Title: Aerial Trolley Re-enforcement

Date: September 29, 2016

Vehicles: *Predator Panther Aerial, Predator Aerial, Predator SS Aerial, Predator TDA and Predator SS TDA*

Problem: Possible separation of the aerial trolley from the fly section of the ladder.

MATERIAL: SEE BOM	DRAWN BY: J CURRIN	DATE: 2/10/2015	KME FIRE APPARATUS	
TITLE: TROLLEY GUIDE KITS	DWG/PART NO: 95478110	REV.	SHT. 1

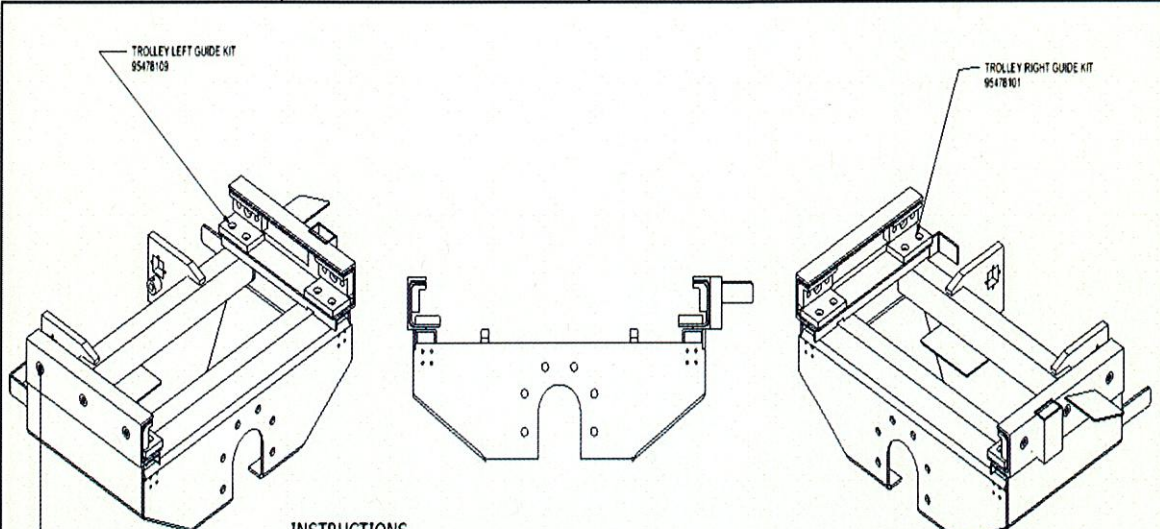
BOLT FOR TROLLEY GUIDE PAD THREE (3) PER SIDE

TWO BOLTS LOCATED AT EACH CHANNEL END WILL BE USED TO SECURE THE REPLACEMENT GUIDES. THE CENTER BOLT WILL NOT BE USED FOR THE REPLACEMENT KIT.

- o REMOVE THE 3 BOLTS THAT SECURE THE EXISTING GUIDE PAD ON EACH SIDE
- o REMOVE EACH EXISTING SINGLE PIECE SLIDE BY SLIDING OUT ONE END
- o INSTALL THE APPROPRIATE GUIDE ASSEMBLY KIT AND BOLT IN PLACE USING TWO BOLTS PER SIDE THAT WERE USED FOR THE SINGLE PIECE GUIDES
- o CAUTION THE LEFT AND RIGHT GUIDE ASSEMBLIES TO BE INSTALLED AS SHOWN DO NOT REVERSE INSTALL THE LEFT AND RIGHT SIDE ASSEMBLIES
